San Onofre Nuclear Generating Station
Unit 1

RESPONSES TO NRC REQUEST FOR
INFORMATION, TURBINE BUILDING RESPONSE SPECTRA

Impell Report No. 01-0310-1451
Revision 0

July, 1985

DAMPING = .0200

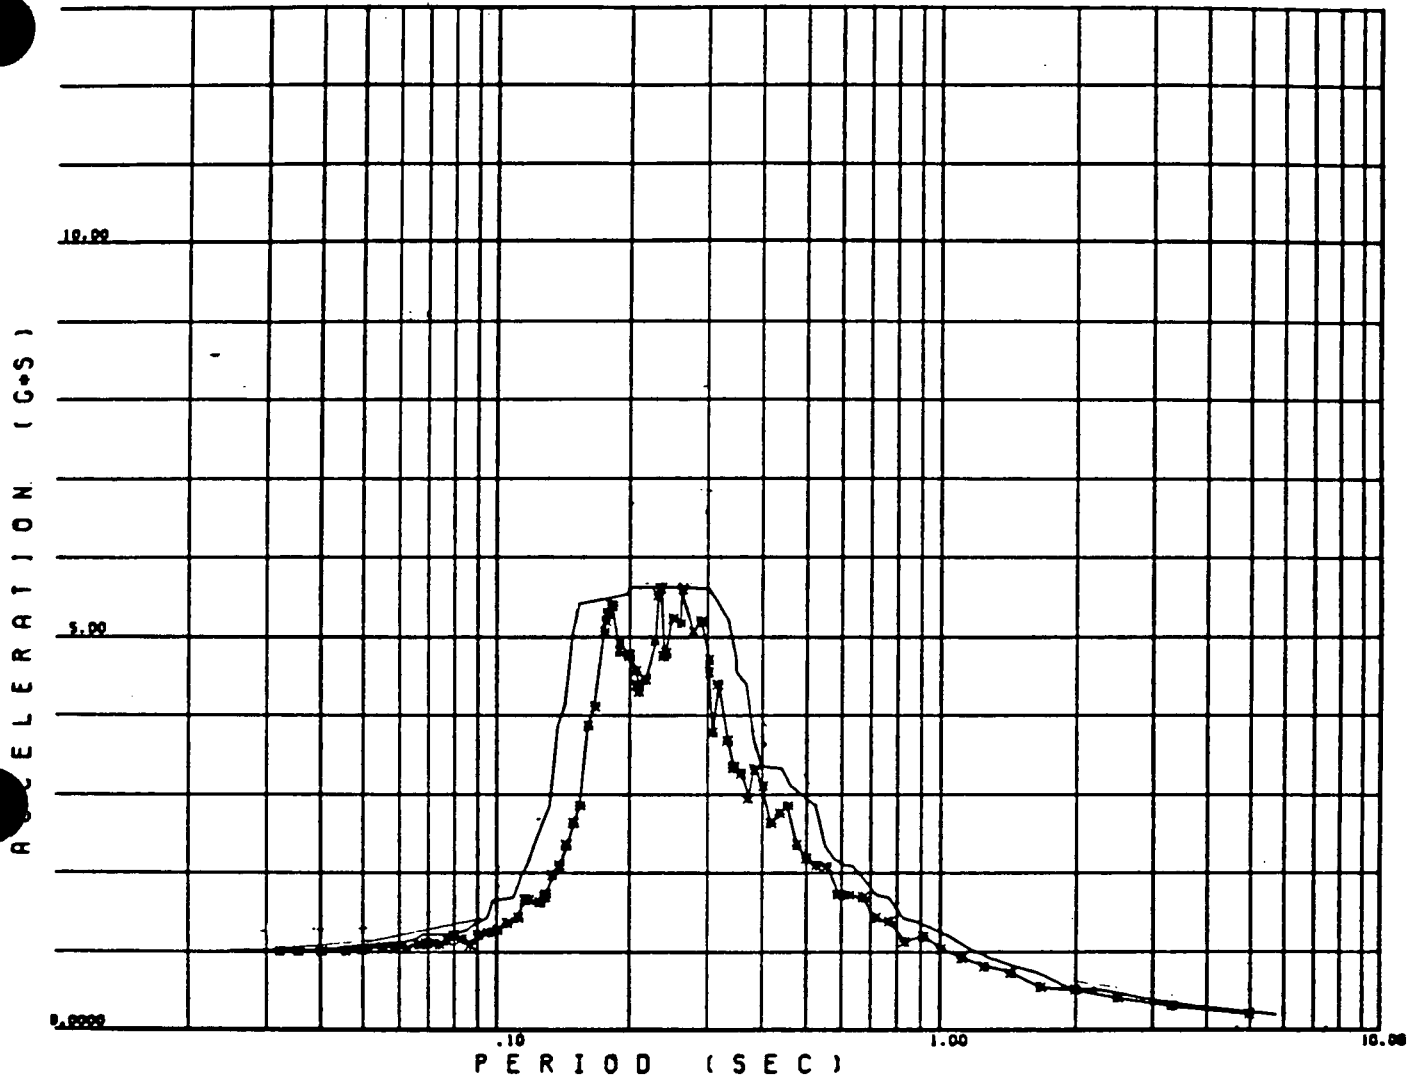
Provide comparison of Turbine Building floor response spectra with previous Bechtel spectra at two locations.

Raw response spectra, for 2% damping, generated by Impell and those generated by Bechtel are provided for the following locations:

- 1) Nodes 580, 586 and 610 in Area 2, North Extension, Elev. 42.0' for North-South Direction.
- 2) Nodes 29, 71 and 86 in Area 6, West Heater Platform, Elev. 35.0' for East-West and Vertical directions.
